# SSD 7033: Response to Submissions

Site 53, 2 Figtree Drive, Sydney Olympic Park

May 2016

FIGURE 3 – PARAPET TREATMENT – DESIGN ITERATION PRESENTED TO DRP

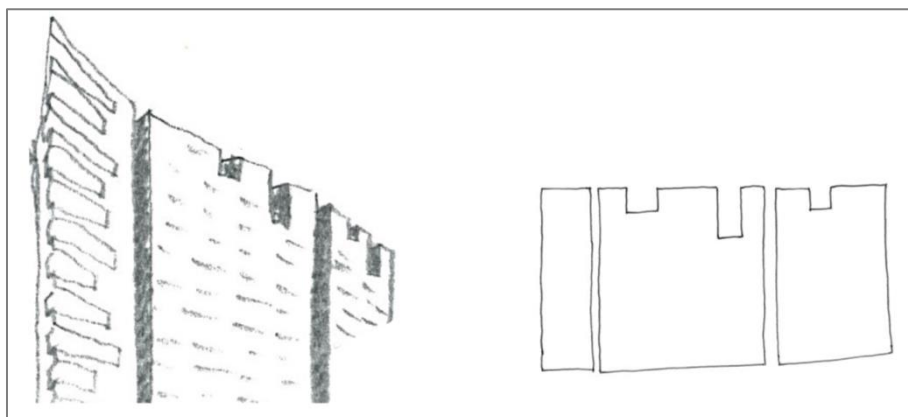
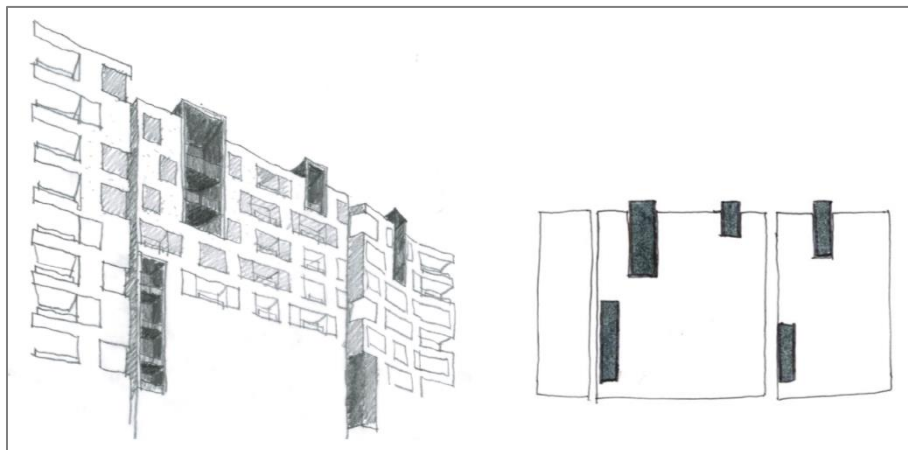
**Building height:** *It is noted that the maximum building heights have gradually increased from 10 to 16 stories through the design development process. The Authority's Design Review Panel (DRP) has generally supported these changes but was concerned that the building articulation shown in earlier sketches has somehow disappeared and that the tallest block now appears quite monolithic. Some of the original design features such as the castellated parapet at the top of the building (which helped to reduce the visual impact of the extra height) has now been infilled. The EIS has not responded to this issue and it is recommended that the original design of the parapet be reinstated as requested by the DRP.*

As shown in the Design Report prepared by BVN and included at **Appendix B**, an iteration of the design scheme presented to the SOPA Design Review Panel introduced a castellated parapet line as a way to break down the scale of the built form (refer Figure 3).

The SSD application scheme facade is a development of this idea of reducing the scale of the built form with brick framed 'pop-out' elements (refer Figure 4). These framed brick elements articulate the façade and introduce variation in the materiality.

The use of brick creates a relationship with the podium brickwork. The 'pop-outs' are positioned along the parapet line as well as throughout the facade to further reduce the bulk and scale of the building and add special elements and articulation to the facade.

FIGURE 5 – BUILT FORM ARTICULATION – BRICKWORK

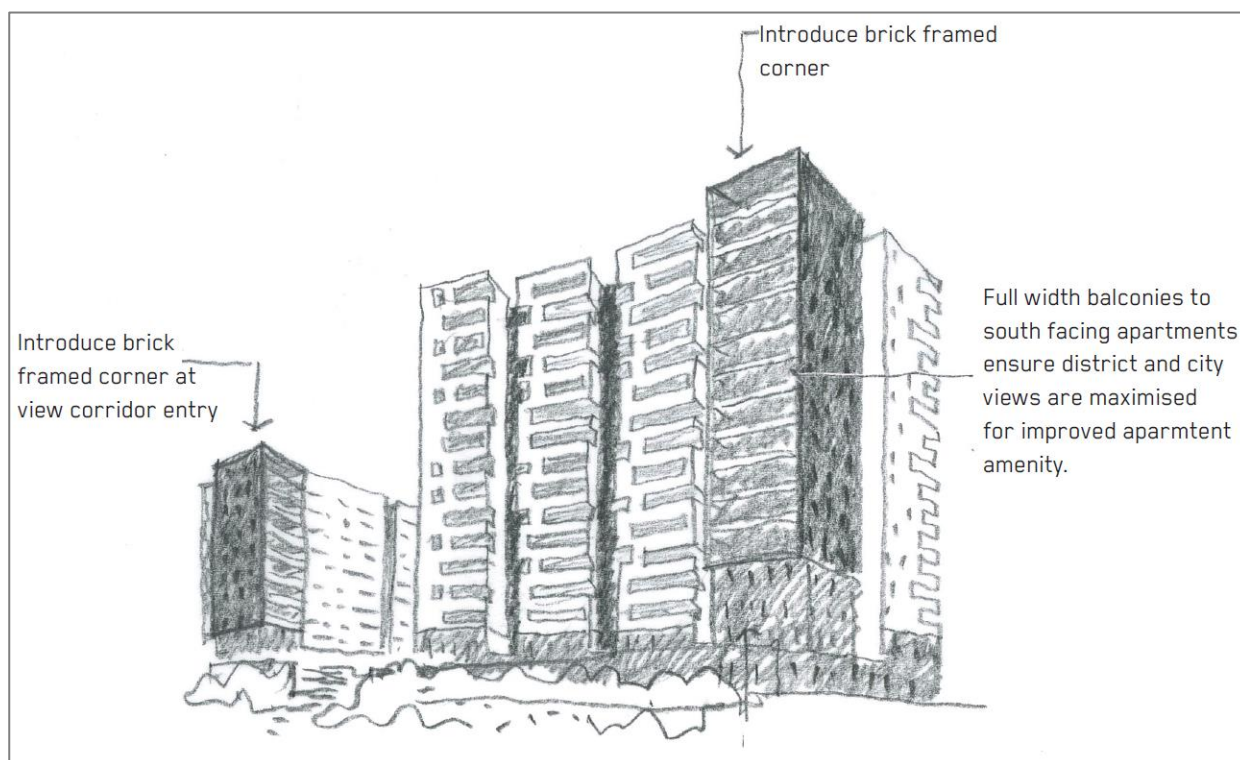
**Face brickwork:** The use of face brickwork in this project is strongly supported. It will help to add warmth and texture to the urban character of Sydney Olympic Park. One concern is that earlier sketches showed the feature corner with a strongly expressed window pattern which has disappeared from the DA scheme and been replaced with full width balconies on the most visible (SE facing) frontage. It is recommended that the facebrick character of the SE frontage be reinstated to match the lower levels (1 to 3) of this tower element.

Face brickwork is heavily featured throughout the proposed development. The face brick character of the south-east frontage is retained through the inclusion of two brick framed corner elements on the south-east and south-west buildings, which relate to the podium below (refer Figure 5).

The previously proposed window pattern on the south-east corner of the fifteen-storey tower has been replaced with full width balconies to south facing apartments in order to provide adequate residential amenity, in particular these apartments will have greater access to district and city views and natural daylight despite their southerly orientation.

FIGURE 6 – SECTION THROUGH AUSTRALIA AVENUE FOOTPATH

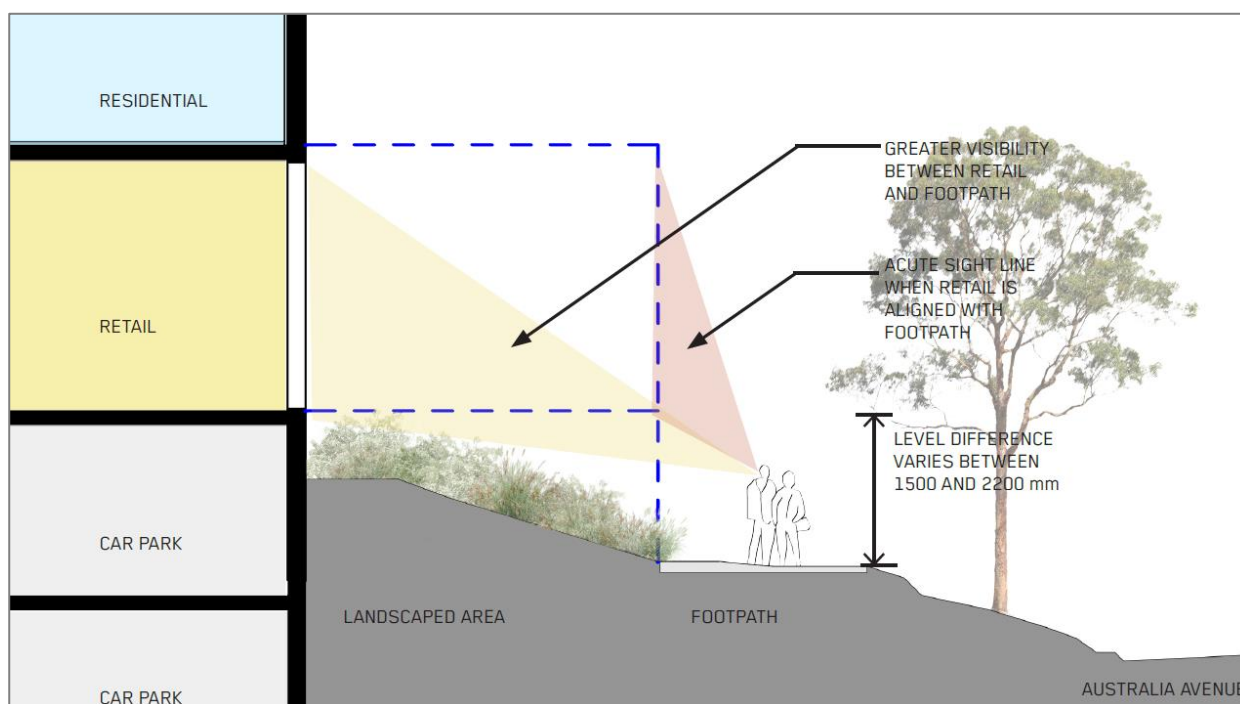
**Development Boundary - Australia Avenue frontage:** *The building footprint does not extend to the master plan boundary on Australia Avenue, resulting in a heavily landscaped setback that gives a very suburban feel to this major frontage at the entry to the town centre. It is recommended that the ground level retail area be extended to the street boundary as shown in attached marked up sketches (SK01 and SK02). The use of brickwork for this frontage is supported.*

The footpath along Australia Avenue follows the natural slopes from Figtree drive down towards the Linear Park and the railway line. The retail RL is set so that the space is directly connected to the Fig Tree courtyard. To maximise flexibility and minimise accessibility issues, the whole retail lot has a consistent floor level. Consequently, the difference in level between the Australia Avenue footpath and the retail lot varies from 1500mm to 2200mm.

To address this level change the building has been setback from Australia Avenue to allow a terraced landscape setback (refer Figure 6). Maintaining this setback will improve visibility of the retail windows and the landscape strip will provide a higher level of amenity for those using the footpath.
